Model: IF2		Date: 31-Jul-97	No: 001
Modified Article: FCU (Firmware)		Prepared by: Y.Tamaoka	
From: QAC 2nd Field Information Dept.			
Reason for Modification:	<input type="checkbox"/> Parts catalog correction <input type="checkbox"/> Vendor change <input type="checkbox"/> To meet standards <input type="checkbox"/> To facilitate assembly <input checked="" type="checkbox"/> To improve reliability () <input type="checkbox"/> Part Standardization <input type="checkbox"/> Other		
Modification Schedule

Model: IF2		Date: 30-Sep-97	No: 002
Modified Article: OP - COVER		Prepared by: Y.Tamaoka	
From: QAC 2nd Field Information Dept.			
Reason for Modification:	<input type="checkbox"/> Parts catalog correction <input type="checkbox"/> Vendor change <input type="checkbox"/> To meet standards <input type="checkbox"/> To facilitate assembly <input checked="" type="checkbox"/> To improve reliability () <input type="checkbox"/> Part Standardization <input type="checkbox"/> Other		
Modification Schedule

MB Correction

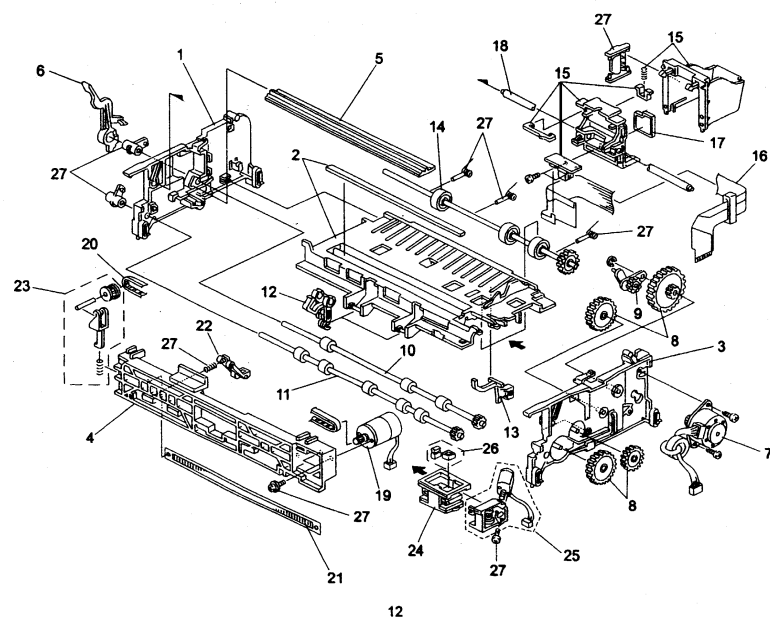
Old part number	New part number	Description	Qty	Int	Page	Index	Note
H9053020		Gear:Spur:Idler:Op			9	20	1
	H9053028	Gear:Idler:Limiter	1		9	26	2
	H9053029	Spring Clutch Ass'y	1		9	27	2

Note 2

Parts information was missing.

2.OP COVER(H905)

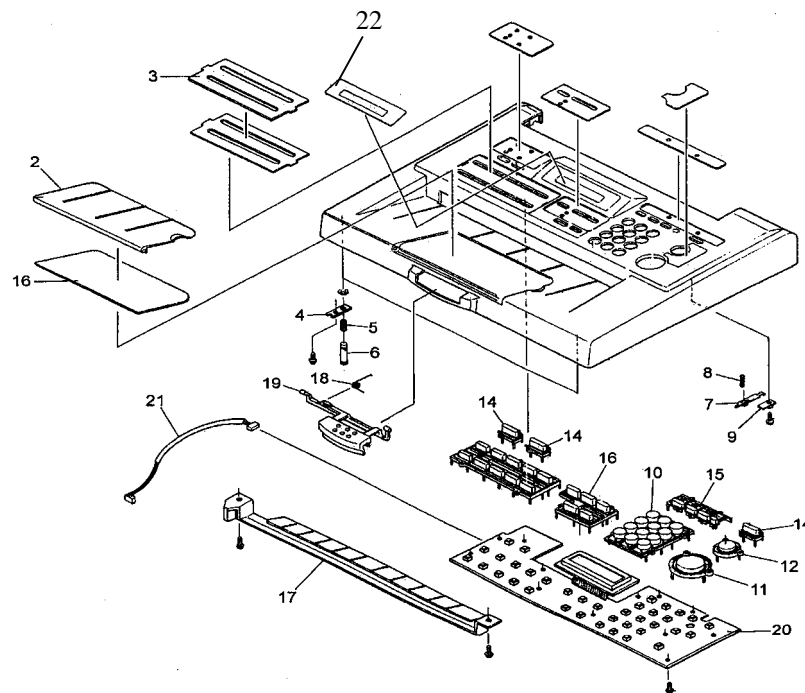
Old part number	New part number	Description	Qty	Int	Page	Index	Note
	H9051101	WINDOW LCD:RICOH	0 - 1		5	22	
	H9051102	WINDOW:LCD:INFO	0 - 1		5	22

Window : LCD is required when the operation panel cover is replaced.

4. SCANNER UNIT (H905)

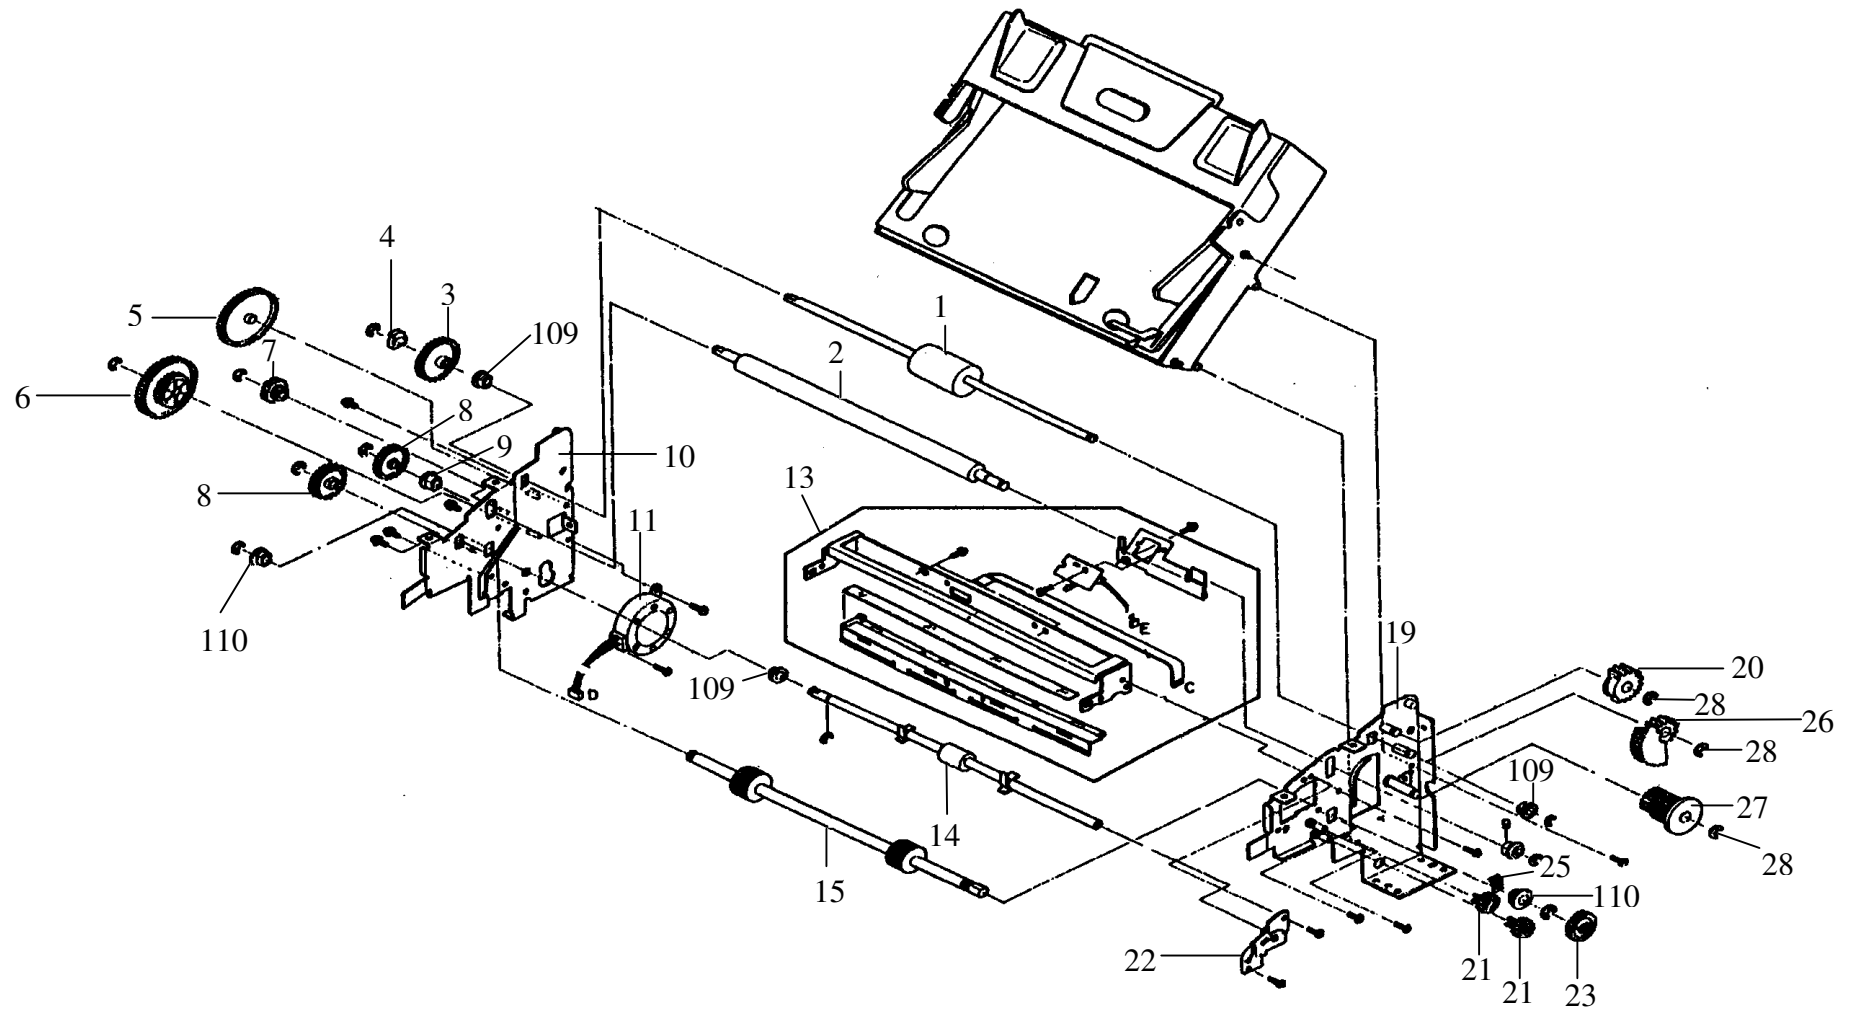
The configuration of gears on the Side plate ass'y : R is totally different from shown on page 8.

Refer to MB IF2-006 for the part numbers of items #26 and #27.
